1979-1985 RX-7

SUBJECT Rear Harness.

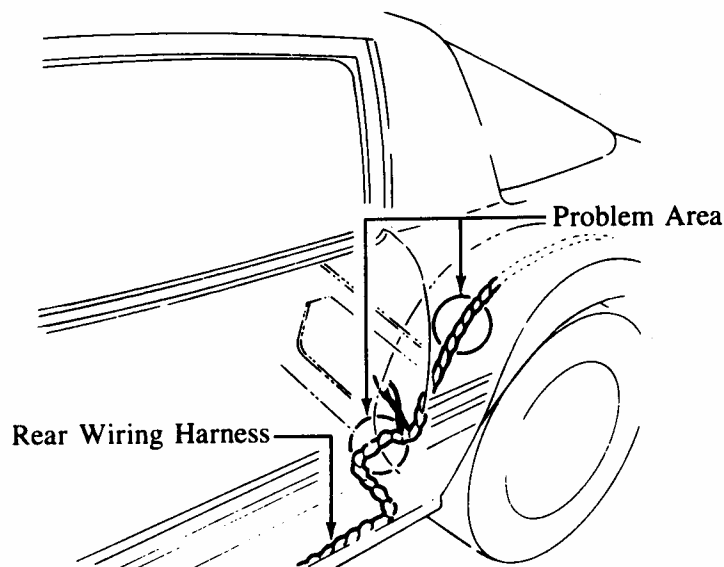
Many electrical problems and blown fuses may be caused by a short circuit in the rear harness. The rear harness may be cut by a sharp metal edge where the harness is routed over the inner wheel well. Some electrical problems reported from the field include:

If this problem is found, repair the rear harness as necessary and wrap the harness with foam rubber to protect the harness from contact with the sharp metal edges in the area shown.

To prevent this problem, the routing of the rear harness has been changed since the production of July 11, 1984.
